CITY OF LA VISTA
MAYOR AND CITY COUNCIL REPORT
DECEMBER 7, 2021 AGENDA

Subject:	Type:	Submitted By:
APPLICATION FOR PUD SITE PLAN AND REPLAT. LOT 19 SOUTHPORT WEST AND LOTS 1-3 SOUTHPORT WEST REPLAT 7	◆ RESOLUTION (2) ORDINANCE RECEIVE/FILE	CHRISTOPHER SOLBERG DEPUTY COMMUNITY DEVELOPMENT DIRECTOR

**CITY OF LA VISTA
PLANNING DIVISION
RECOMMENDATION REPORT**

RE: Planned Unit Development Amendment – Initial Review Letter
Lots 1, 2, and 3 Southport West Replat 7 and Lot 19 Southport West

Figure 1. Proposed site plan for Southport North Lots

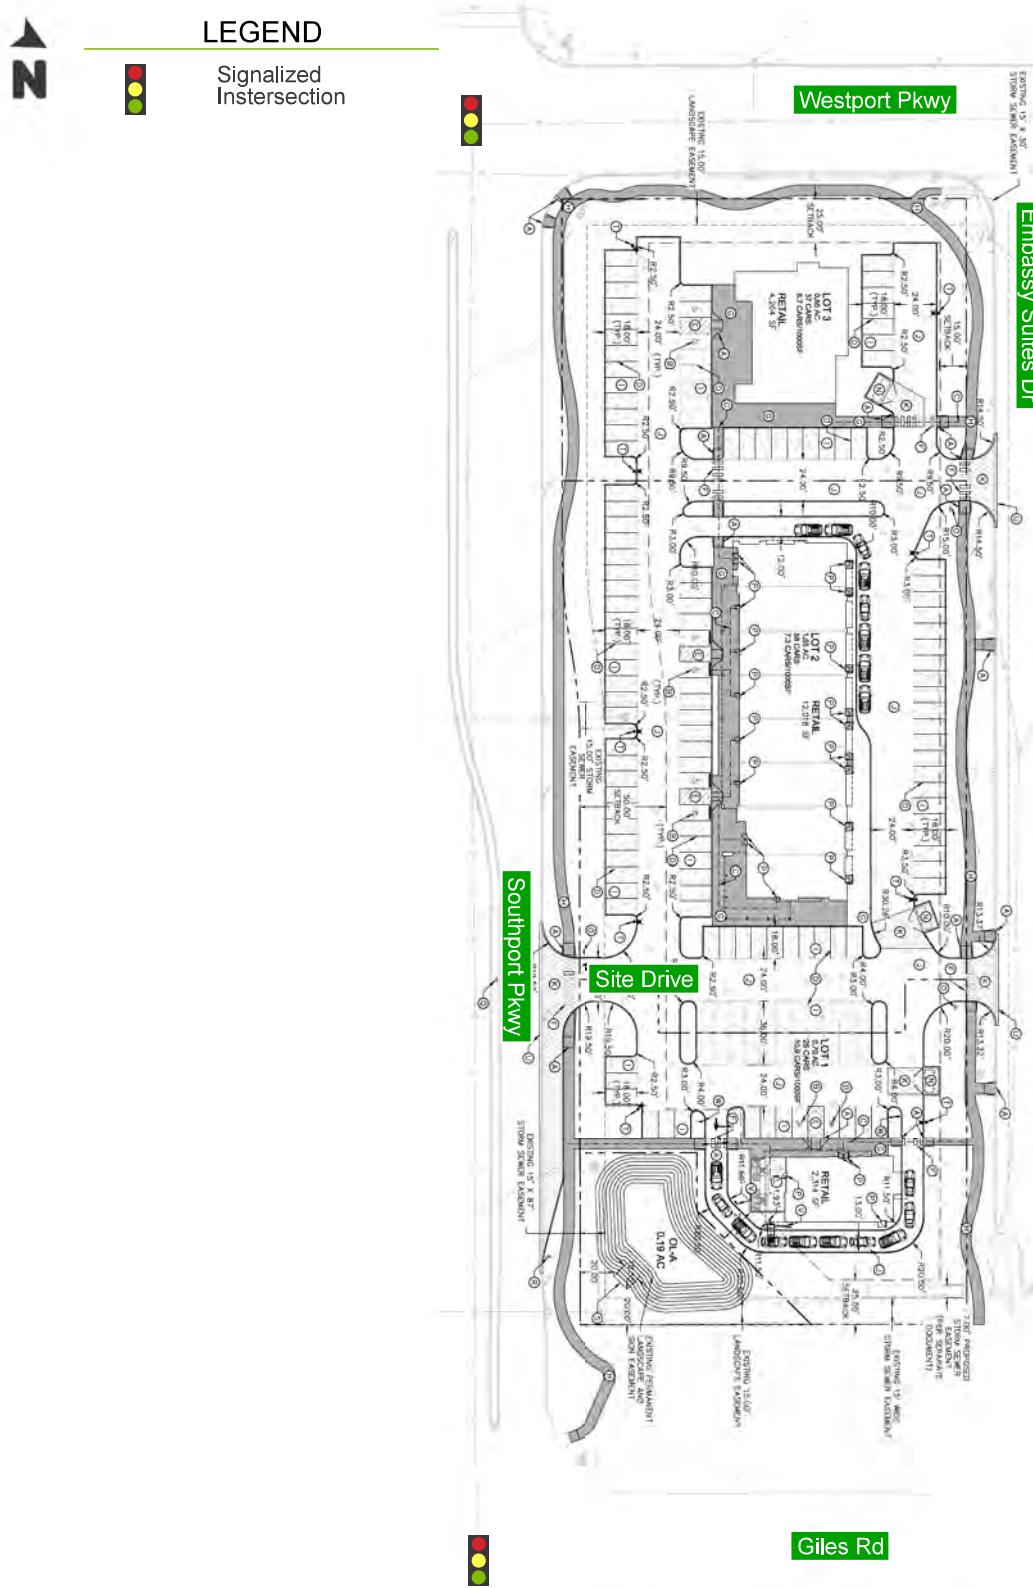
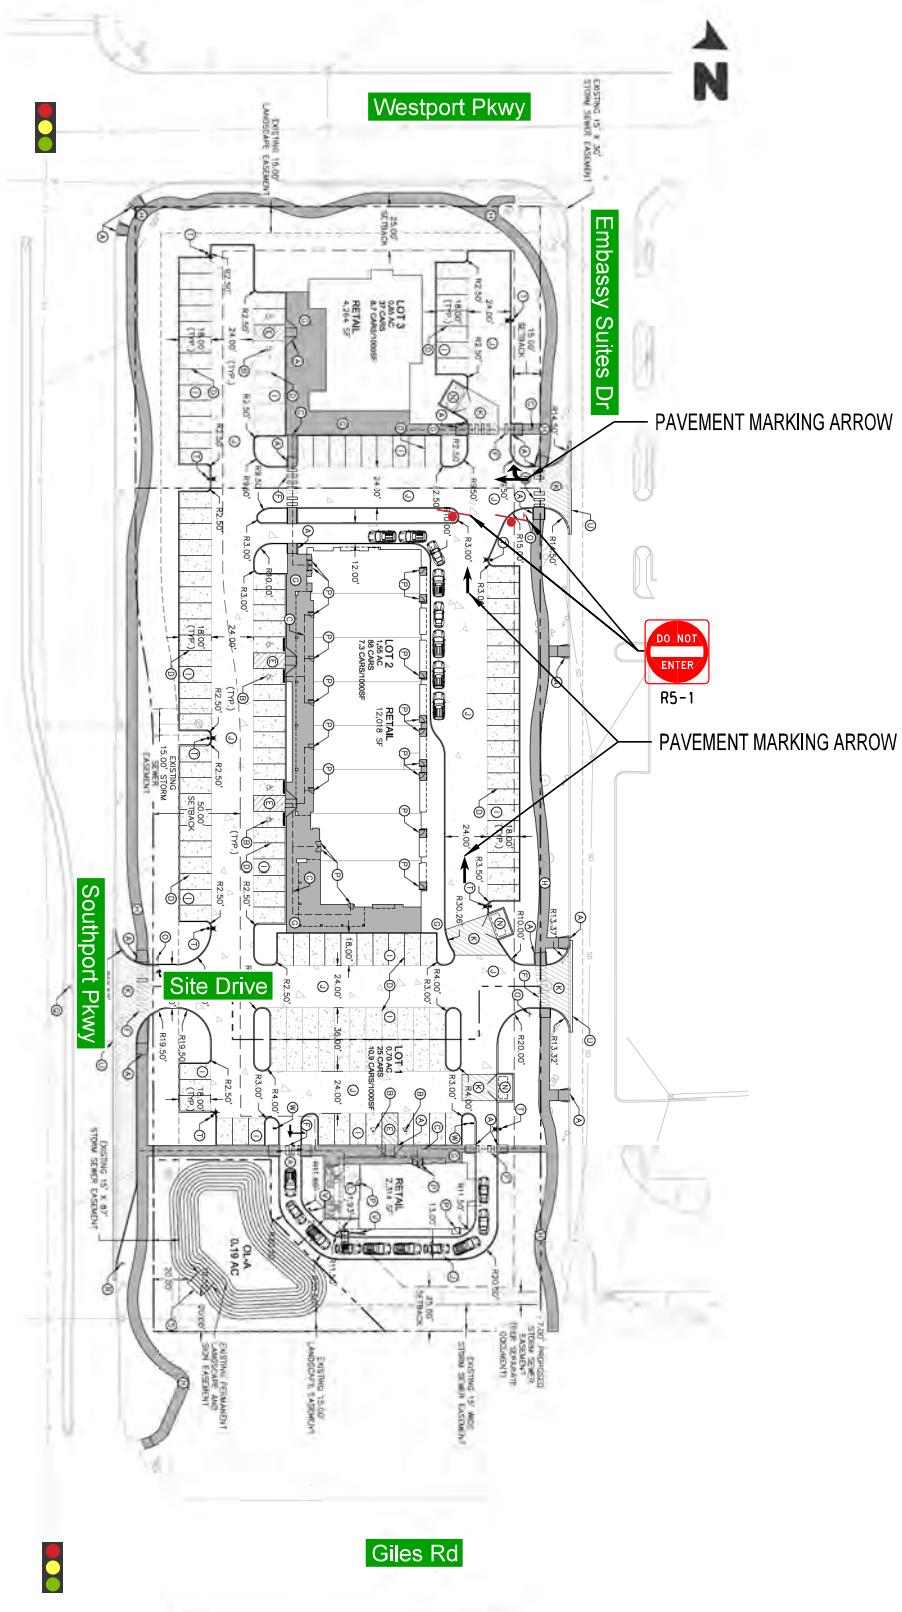
2. Page 6 / Figure 1 & Page 14 / Figure 9: The north arrow on these figures is inaccurate.
Please have the applicant show the correct north heading or reorientate the site plan so north is up on the page.

Figure 3. Pass-by trip distribution

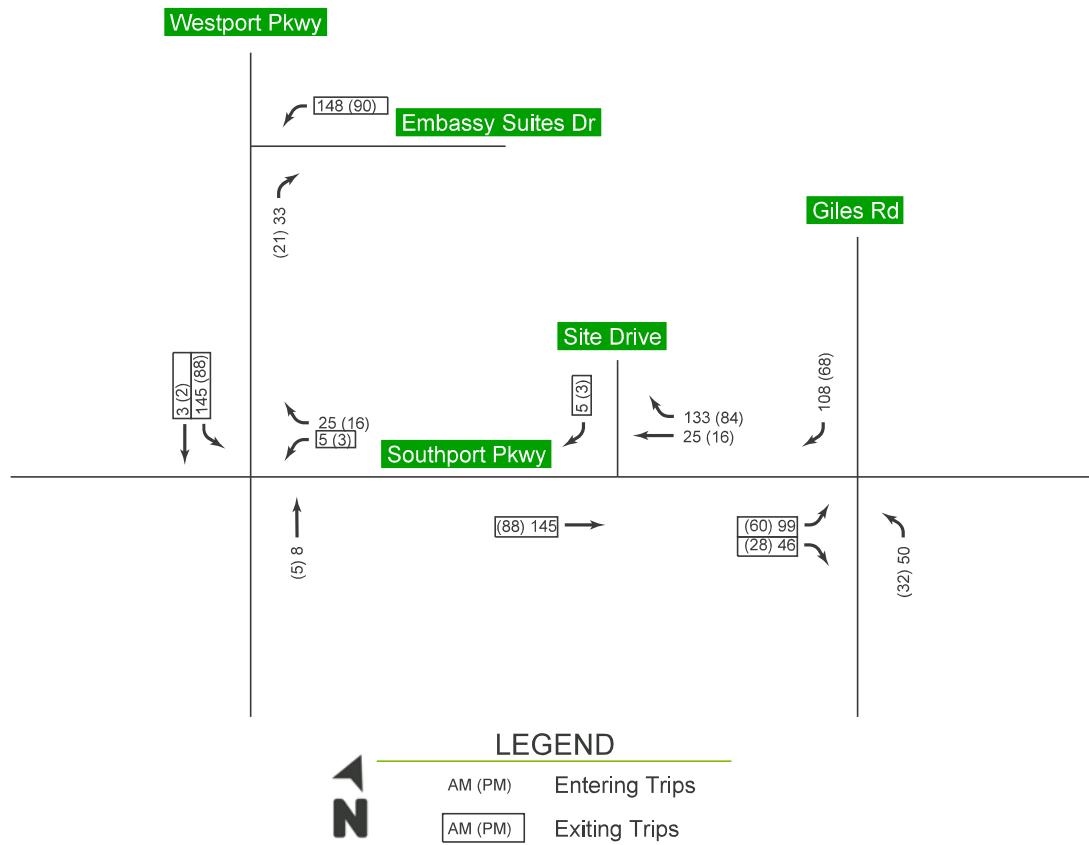
5. Page 4 / Paragraph 3 &Page 8 / Figure 3: At the Site Drive (RIRO access), with only 17 vehicle-trips in the AM and 18 vehicle-trips in the PM, is the right-out justified at this location and a right-in only needed? See example east of Giles Road on Southport Parkway. With the right-in only option, the access point could be shifted further west away from the Giles Road

intersection. A shift west would deter cut through traffic to the Embassy Suites and provide additional on-site staking for the proposed coffee shop. Additionally, limiting the access to right-in only will eliminate the concern of exiting traffic crossing multiple lanes of traffic on Southport Parkway to access the dual westbound left-turn lanes.
